Memorandum to the City of Markham Committee of Adjustment

April 25, 2022

File: A/193/21
Address: 33 Alanadale Avenue – Markham, ON
Applicant: Patrick Lam
Agent: Z Square Group (Mengdi Zhen)
Hearing Date: May 4, 2022

SITE PLAN
A1.1

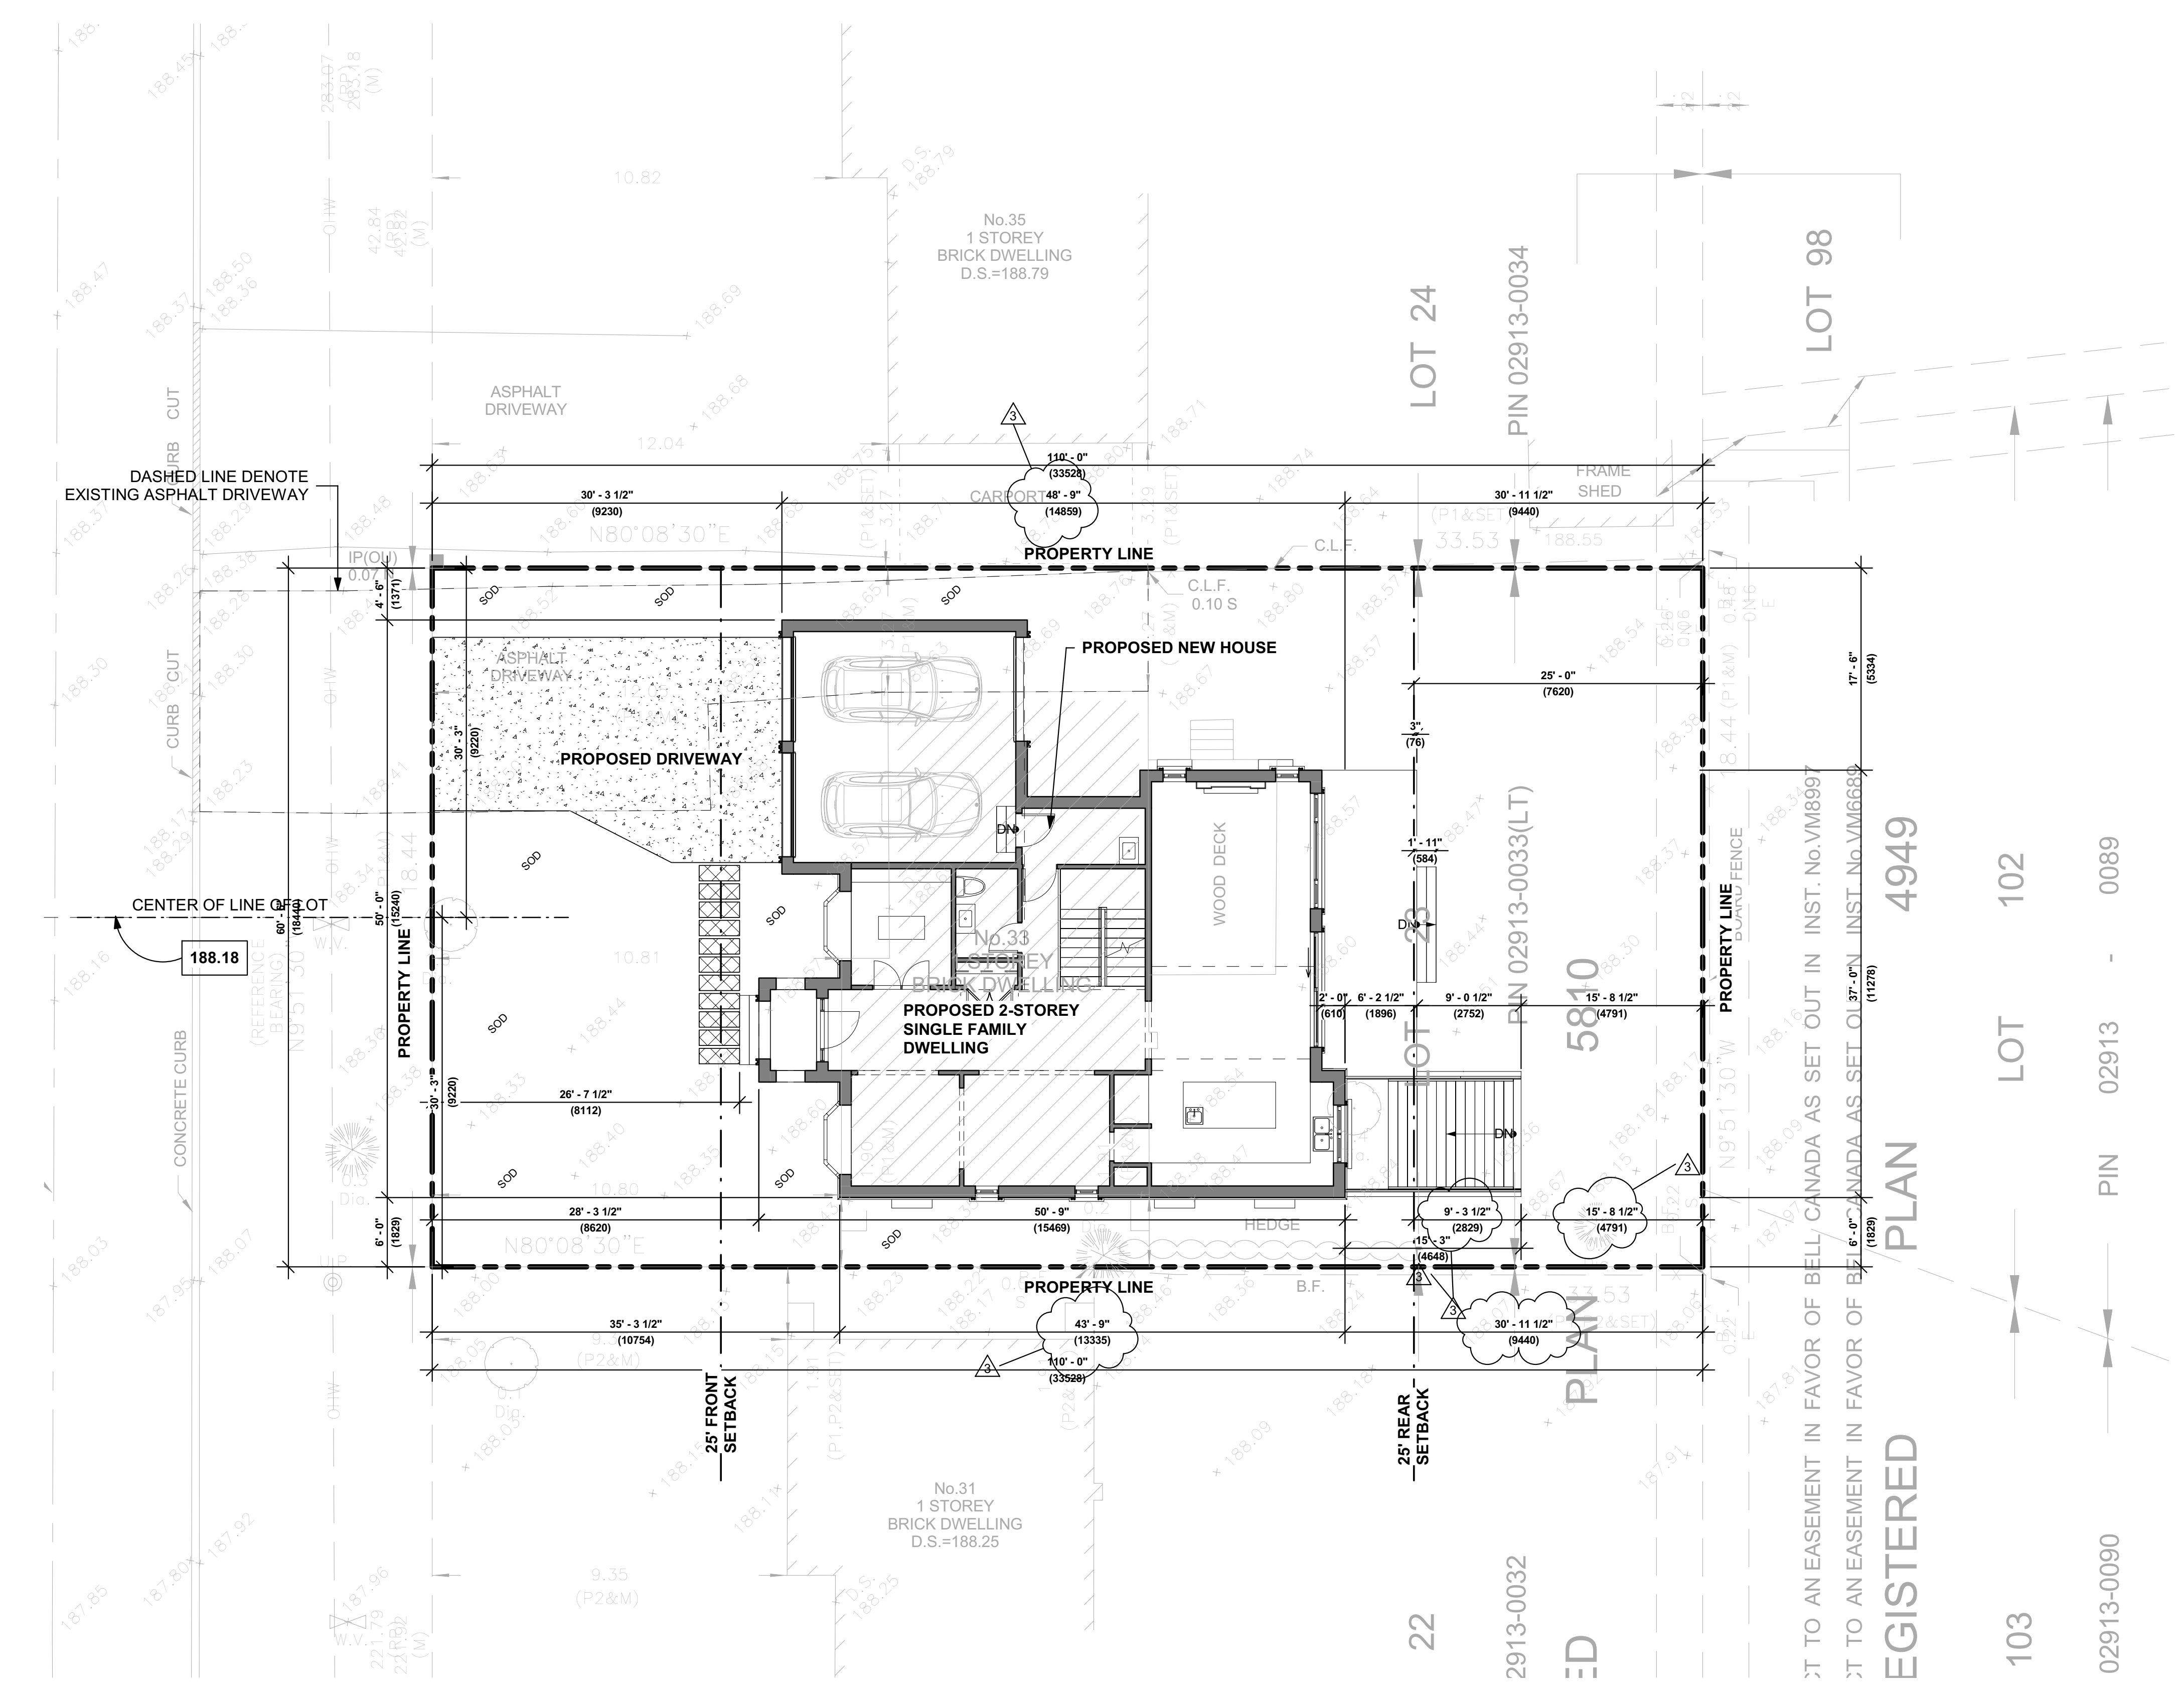
The applicant submitted revised drawings on March 23, 2022. Including the garage area, the new two-storey detached dwelling would have a ground floor area of 175.0 m² (1,883.66 ft²) and, a second floor area of 130.96 m² (1,409.65 ft²), for a total gross floor area of 305.96 m² (3,296.30 ft²). This is a reduction of 5.58 m² (60.06 ft²) from the applicant’s initial submission.

The applicant has also reduced their request relating to an encroachment of basement walkout stairs into the rear yard by 7.62 cm (3.0 inches). With these changes, staff remain of the opinion that the proposed development meets the four tests under the *Planning Act, R.S.O. 1990, c. P.13, as amended*.
